**CALIFORNIA COASTAL COMMISSION**

**STAFF REPORT: REGULAR CALENDAR**

**APPLICATION NO.** 4-98-319

**PROJECT LOCATION:** 21900 Saddle Peak Road, Malibu, Los Angeles County

EXHIBIT NO. 11
APPLICATION NO. Greenhut
4-98-319
Revised Plans:

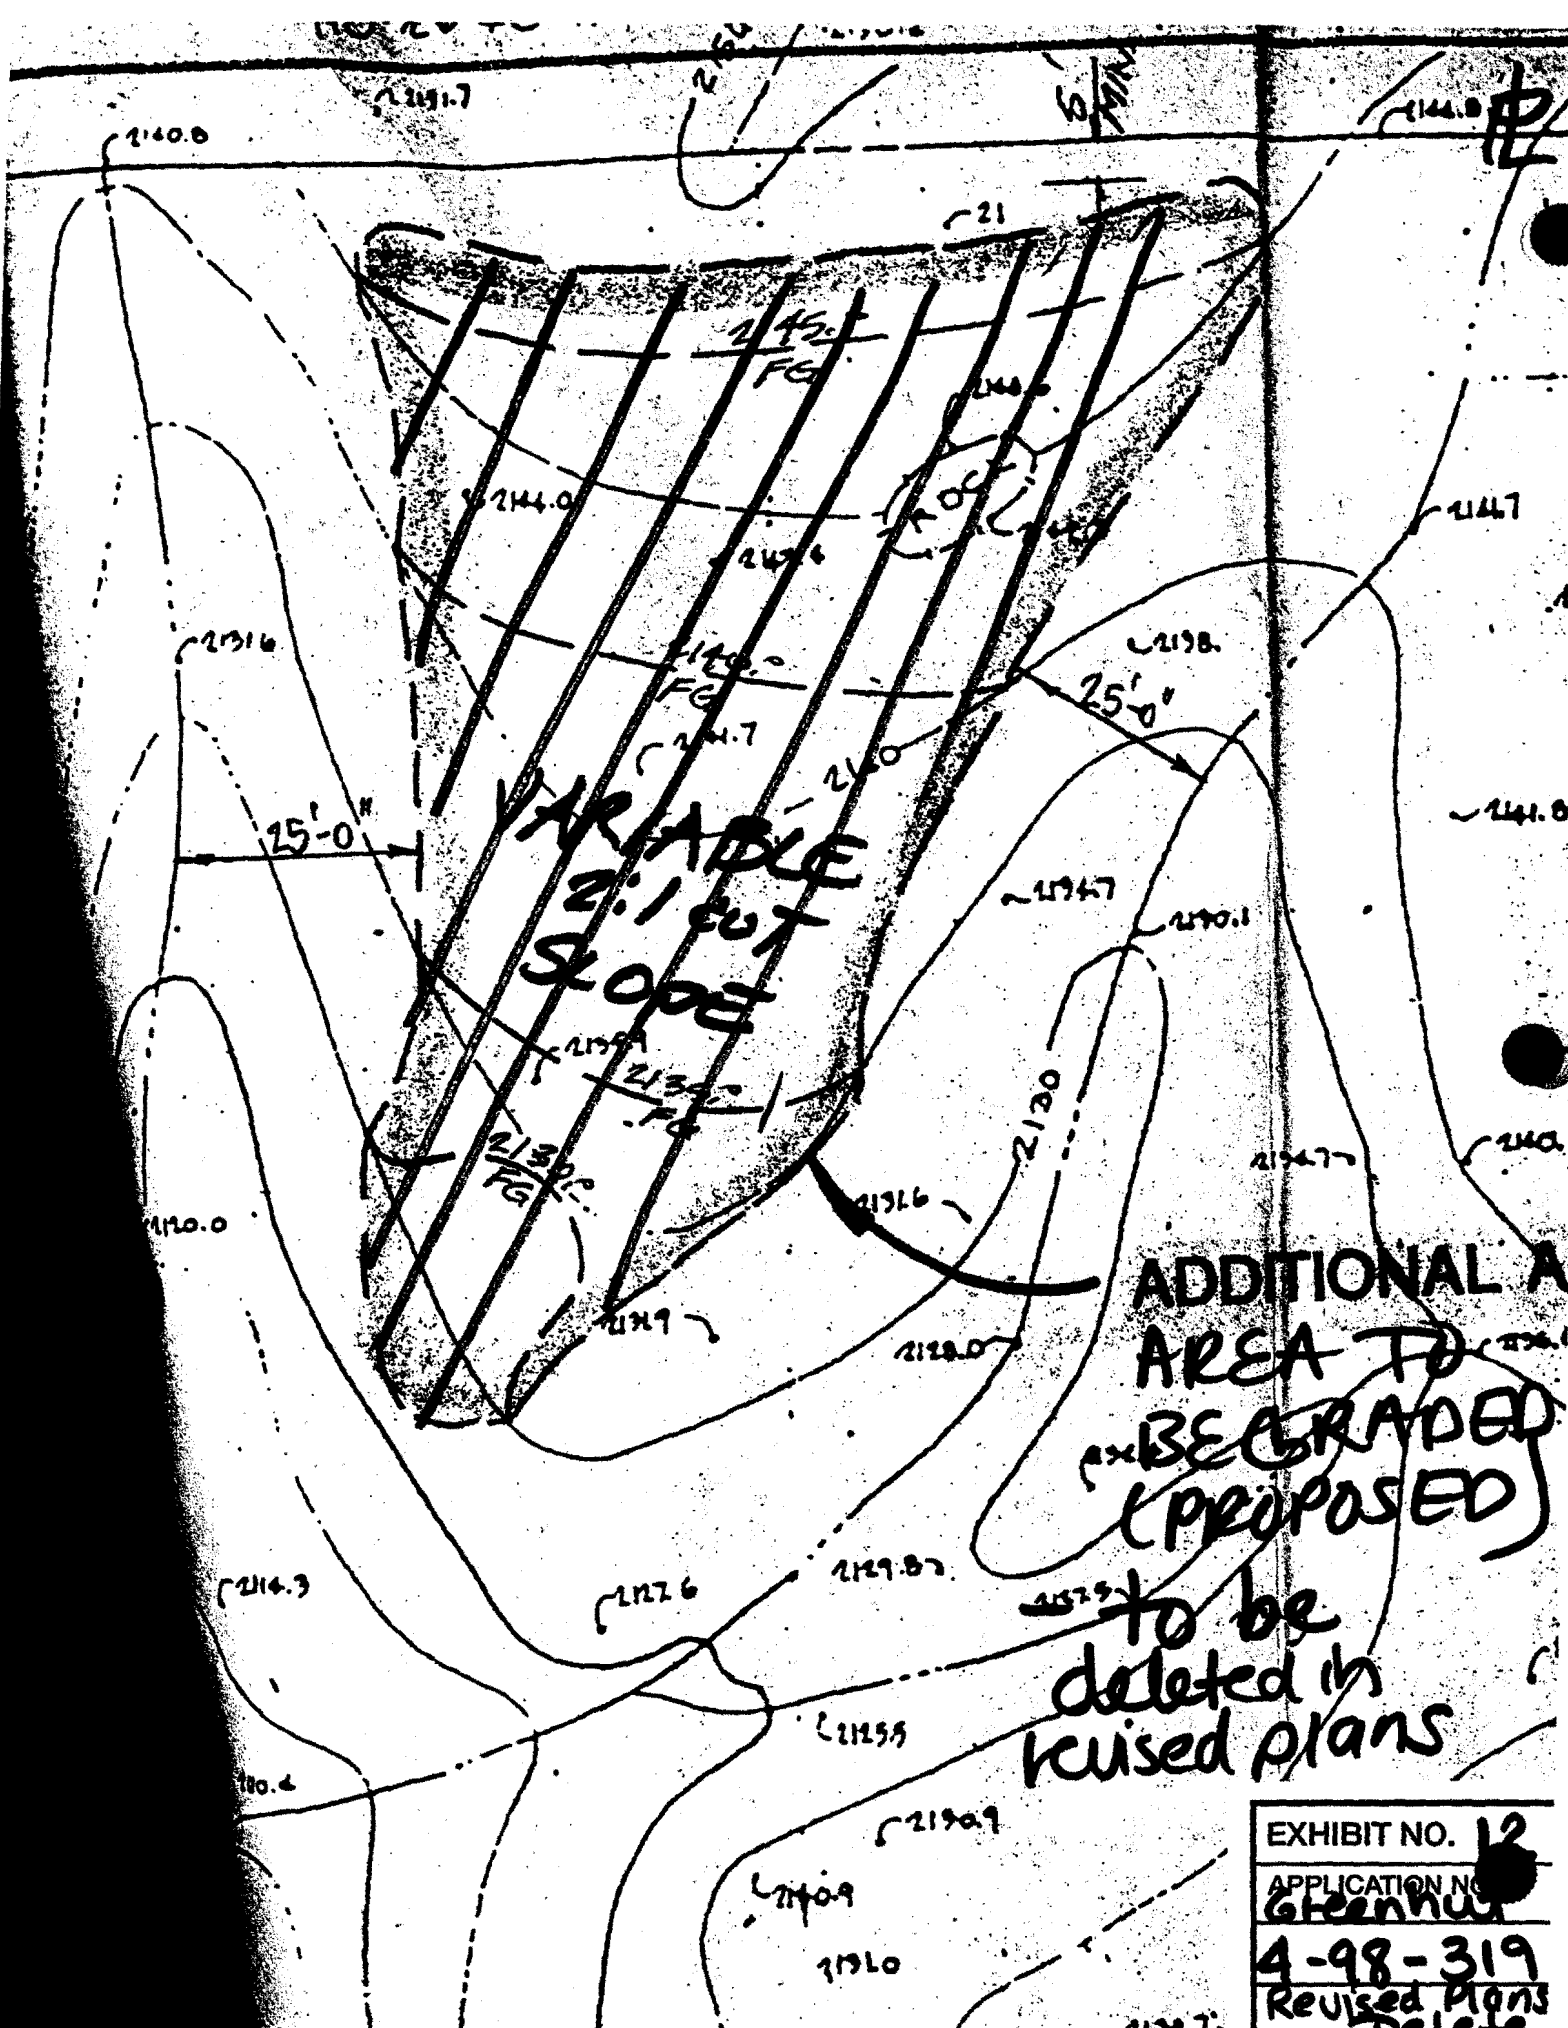
The Commission additionally finds that the proposed grading shown in Exhibits 8 and 11 would remove an artificial landscape feature (a mound) situated between the residence and the swimming pool, that is not part of any natural drainage features on the steeply sloping site. The area containing the mound proposed for grading was previously disturbed during the initial site construction and is artificially landscaped with boulders and sparse plantings. As some erosion is presently occurring on the slopes in this area, the recontouring will equalize drainage sheetflow in this area, and if the erosion control requirements of Special Condition 1 are fully implemented to prevent erosion during winter grading, and if landscape plantings are placed and managed in accordance with an authorized landscape plan prepared pursuant to Special Condition 1, existing patterns of erosion on site may be remediated. In addition, if the recommendations of the geotechnical consultant are implemented pursuant to site preparation, construction, and drainage management as required by Special Condition 2, the Commission finds that the proposed project as revised pursuant to the requirements of Special Condition 3 would not create or contribute significantly to erosion or geologic instability.

*OK on revised plans*

- (a) The revised plans shall retain the grading shown in the area between the rear of the residence and the swimming pool and such minimal grading as may be necessary to reconfigure the existing driveway in front of the main residence to a circular form (Exhibit 11); and
- (b) The revised plans shall eliminate the grading (cut, shown in Exhibit 12, and fill shown in Exhibits 9 and 10) and construction (such as vehicle pad, culverts, retaining walls, and driveway widening and extension) shown by crosshatching in Exhibits 9, 10, and 12.
